AP1000 DOCUMENT NO. APP-GW-GLN-003	REVISION NO. 0	Page of	ASSIGNED TO W-A. Sterdis
---------------------------------------	-------------------	---------	-----------------------------

TITLE: Hydrogen Igniter Locations

Document Number: APP-GW-GLN-003 Revision Number: 0

The purpose of this AP1000 Standard Combined License Application Technical Report is to correct or modify the elevations or locations of certain hydrogen igniters within the AP1000 hydrogen control system. Igniter locations are being adjusted consistent with the physical plant layout. Their number and electrical power grouping are not changed.

Figure 6.2.4-5

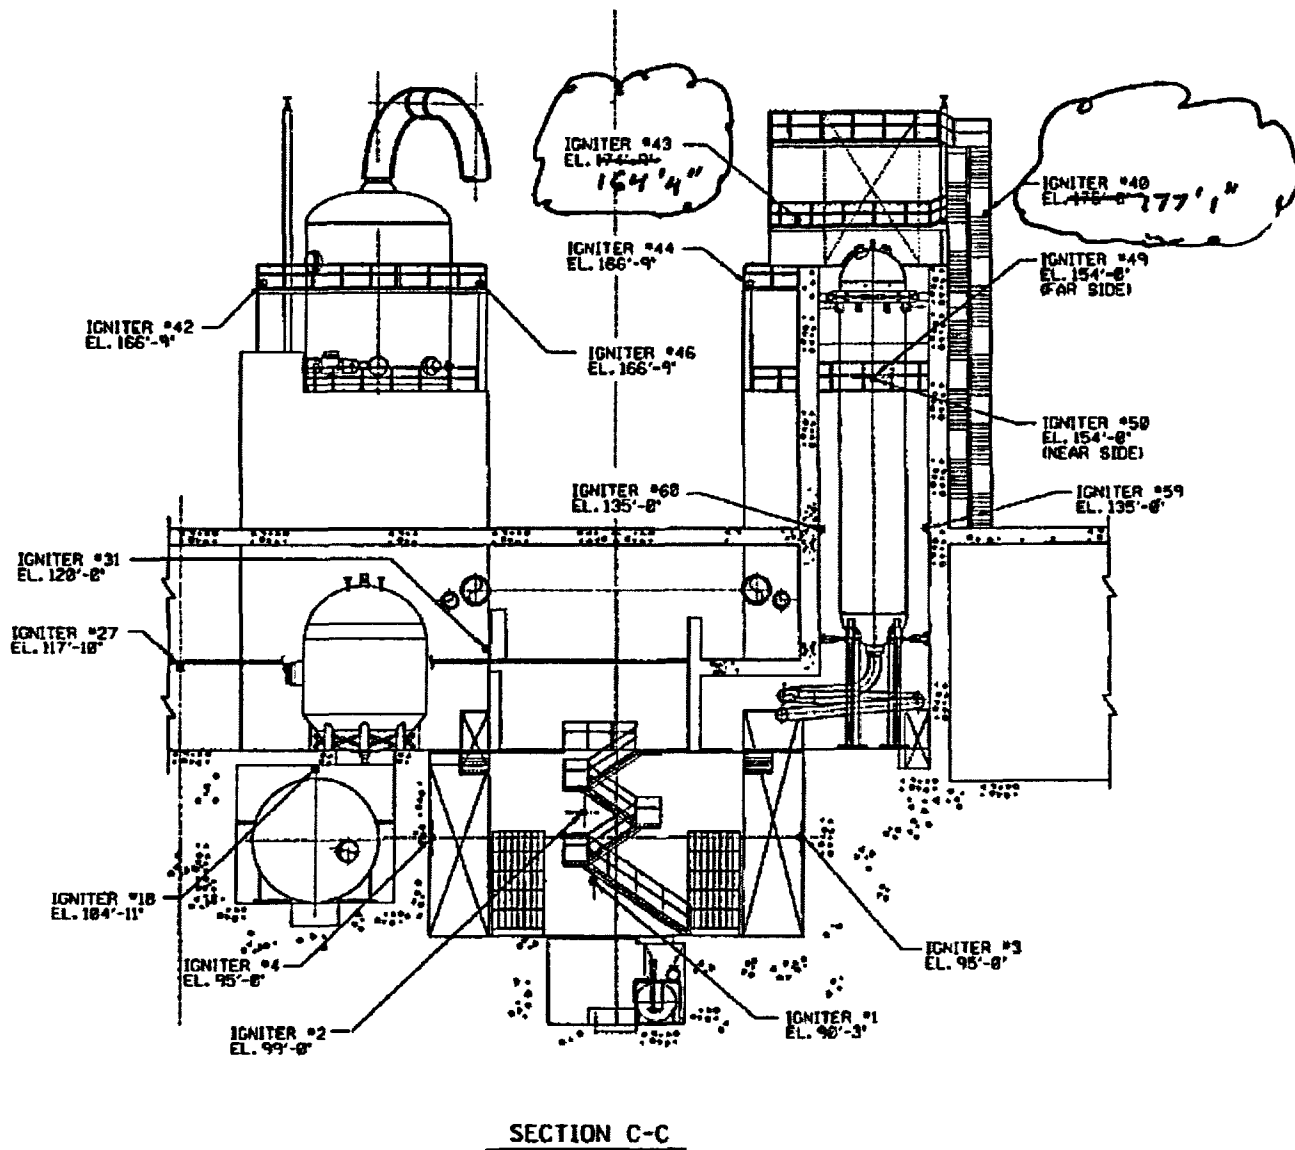
Revise Figure 6.2.4-5 as follows:

Figure 6.2.4-9

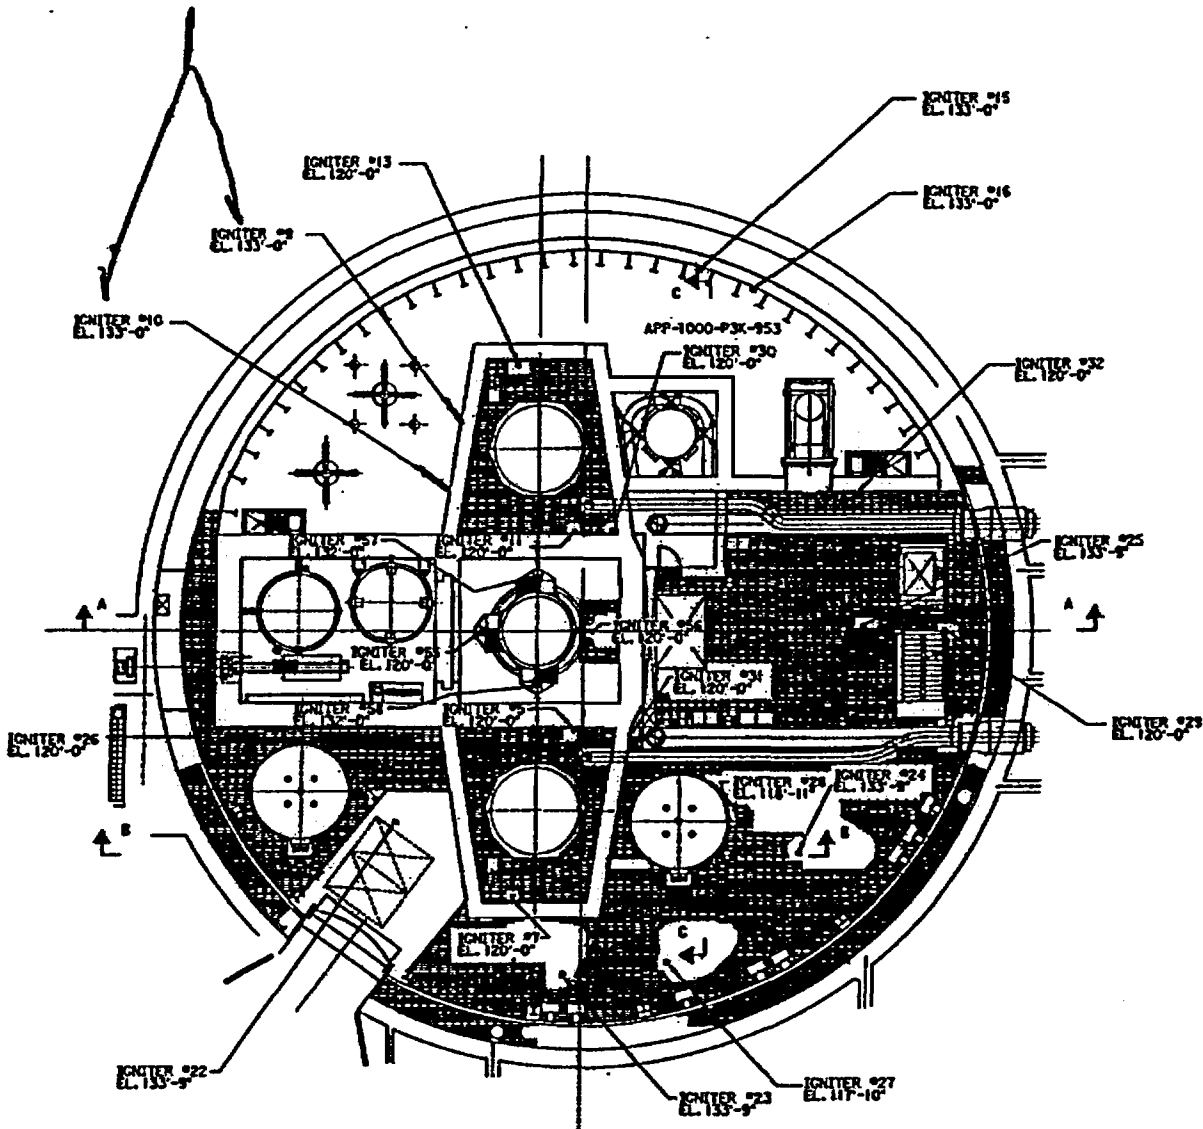
Figure 6.2.4-9 Revise Figure 6.2.4-9 as shown on the next page.

**IGNITER S #9 AND #10 ARE BEING MOVED
CLOSER TO VENTS ALONG THE SG 01 WALL.**

Figure 6.2.4-10

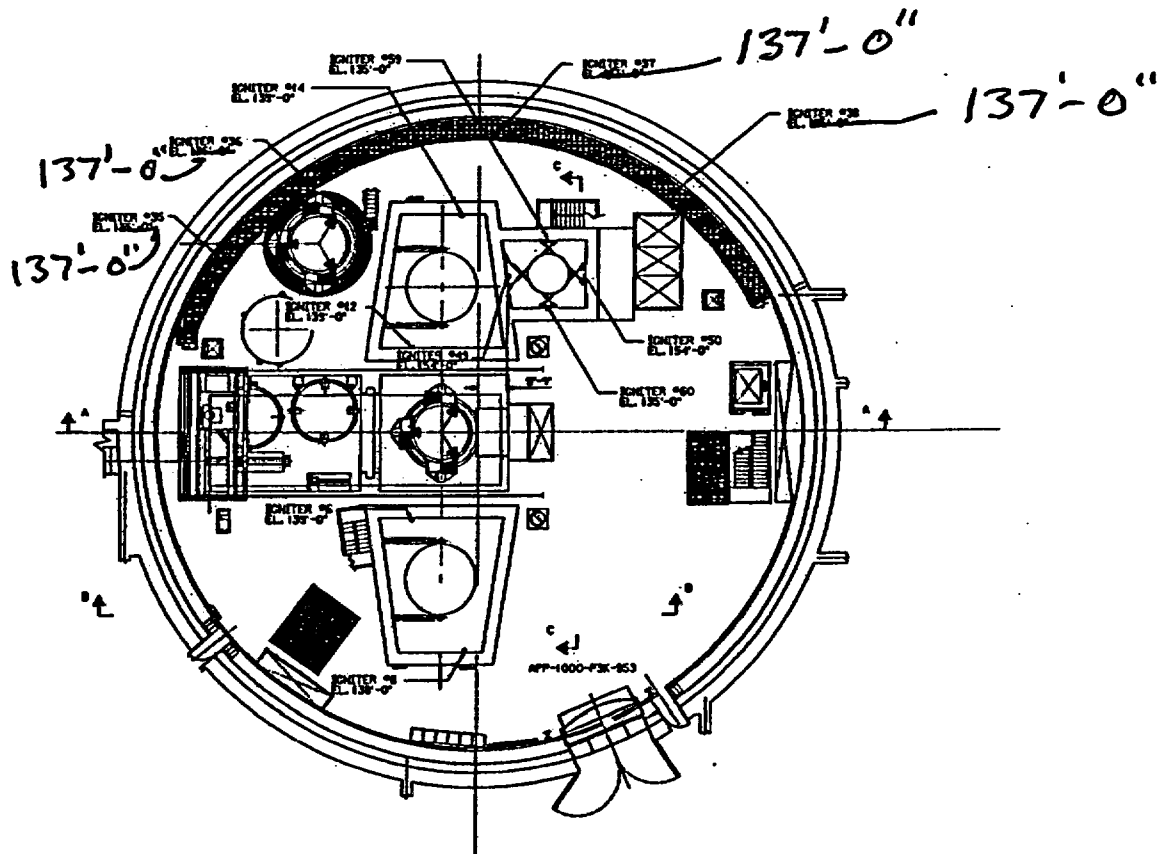
Figure 6.2.4-10 Revise Figure 6.2.4-10 as follows:

Figure 6.2.4-11

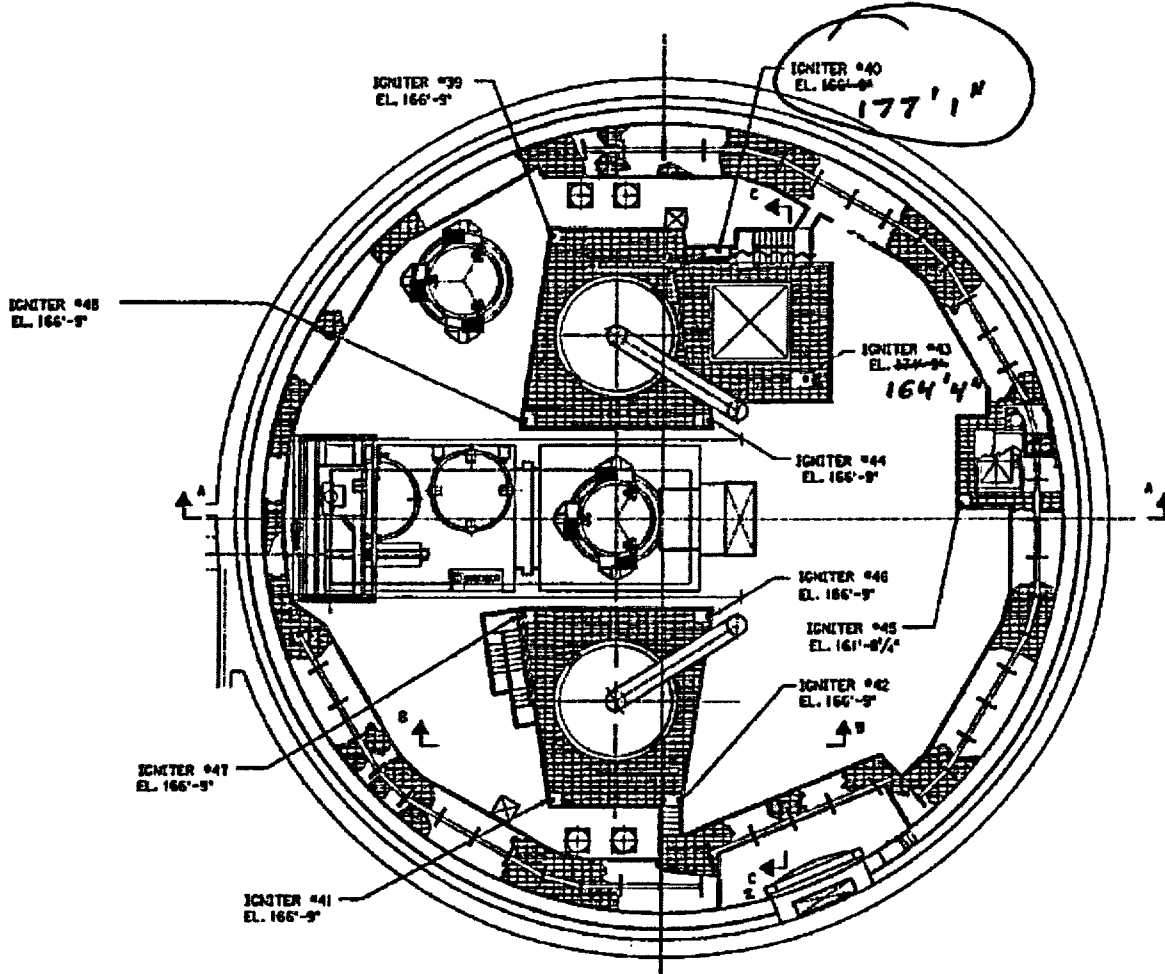
Revise Figure 6.2.4-11 as follows:

Figure 6.2.4-12

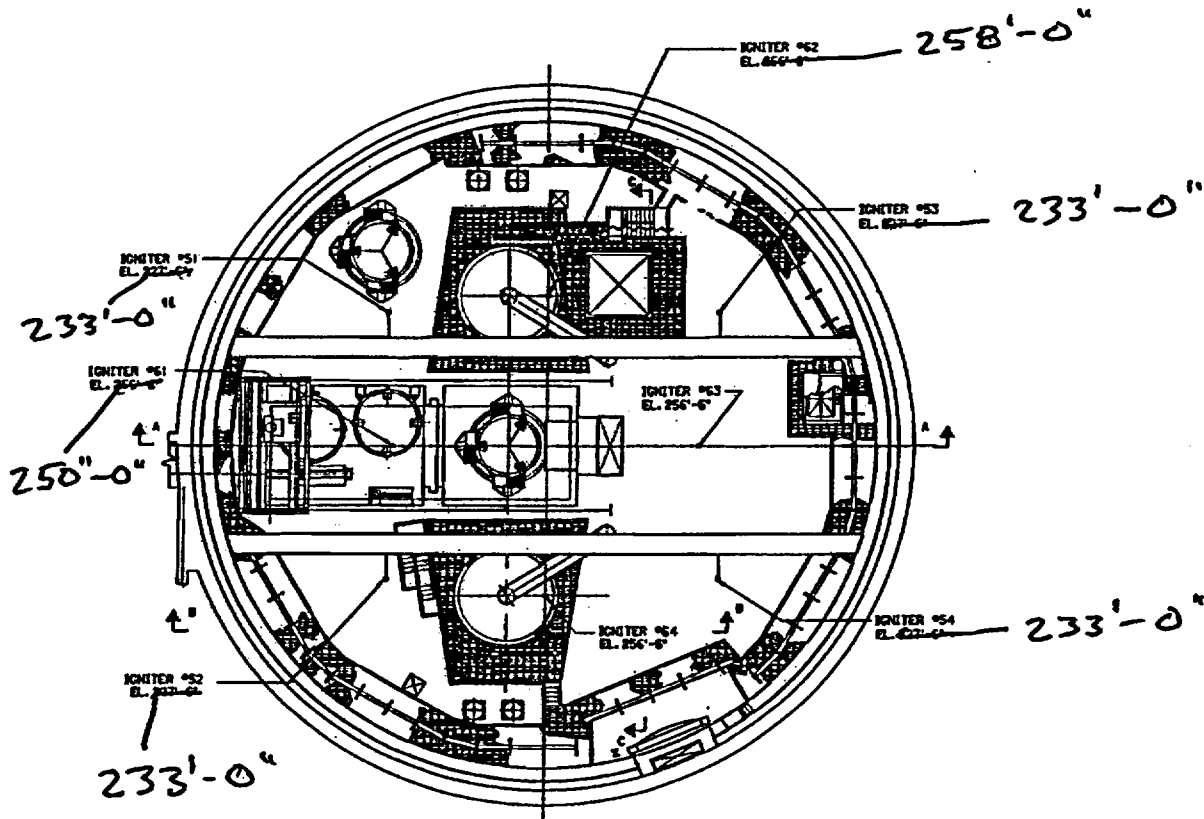
Figure 6.2.4-12 Revise Figure 6.2.4-12 as follows:

Figure 6.2.4-13

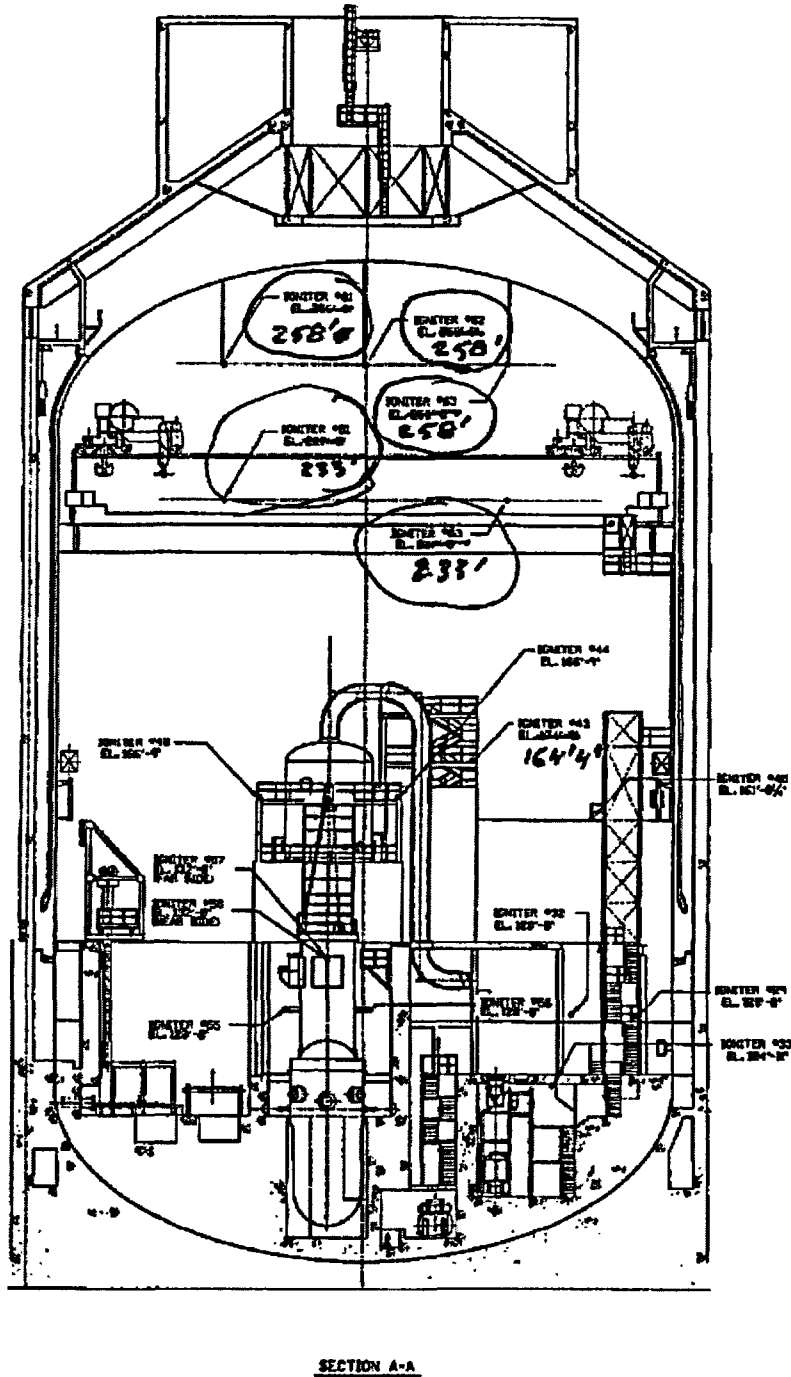
Figure 6.2.4-13 Revise Figure 6.2.4-13 as follows:
